IEEE 802.3cu 100 Gb/s and 400 Gb/s over SMF at 100 Gb/s per Wavelength Task Force

Tx Headroom Budget for 400GBASE-LR4-6

Jan. 20, 2020 R. Okabe, H. Isono Fujitsu Optical Components, Ltd.

Tx Headroom Budget

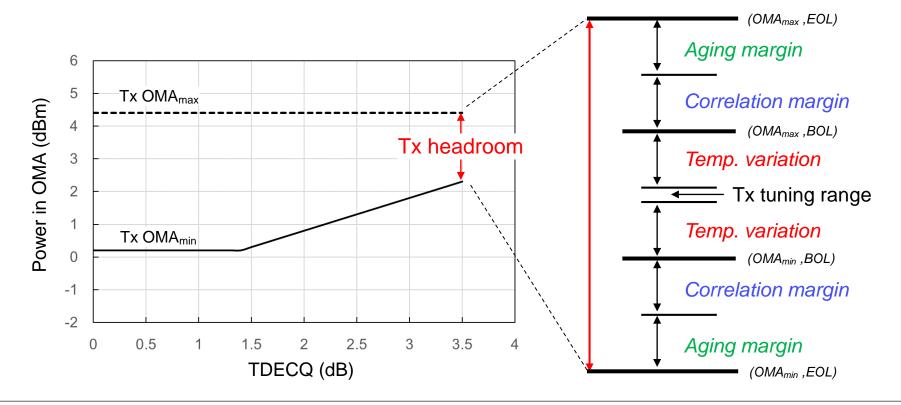
- Manufacturing margins for Tx headroom consist of the following elements;
 - Tx tuning range
 - Temp. variation
 - Correlation margin
 - Aging margin

- ≥ 2.5-dB Tx headroom is required for manufacturing margin on 400GBASE-LR4-6 spec
- 0.4 dB enhancement is highly expected for Tx headroom (from 2.1 dB to 2.5 dB)

Possible Solution for Tx Headroom Enhancement

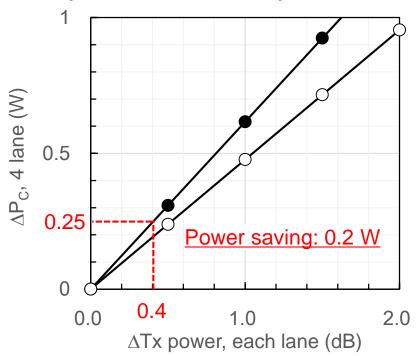
Option-1: reduce Tx OMA_{min} from +0.2 to -0.2 dB by 0.4 dB

Option-2: increase Tx OMA_{max} from 4.4 to 4.8 dB by 0.4 dB

(Rx sensitivity should be changed for corresponding to the option-1 & option-2)

Tx OMA & Rx sens. (expected revision)

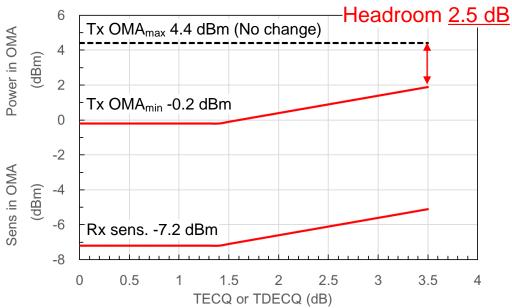
- Thoughts on Tx headroom budget for 400GBASE-LR4-6 was provided. Tx headroom of 2.5 dB is required for Tx tuning range, temp. variation, correlation and aging margin.
- To keep ≥ 2.5-dB Tx headroom for 400GBASE-LR4-6, 0.4-dB reduction for Tx OMA and Rx sensitivity is highly expected.

- Proposed changes: 0.4-dB reduction for Tx OMA and Rx sensitivity
 - Tx changes: table151-7 "400GBASE-FR4 and 400GBASELR4-6 transmit characteristics"
 - Rx changes: equation (151-3) in the section of "151.8.10 Receiver sensitivity"

Figure 151-6—Illustration of receiver sensitivity for 400GBASE-FR4 and 400GBASE-LR4-6

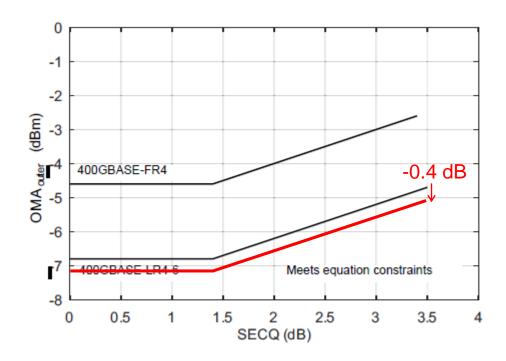
- Proposed changes: 0.4-dB reduction for Tx OMA and Rx sensitivity
- Rx changes: Figure 151-6 "Illustration of receiver sensitivity for 400GBASE-FR4 and 400GBASE-LR4-6"
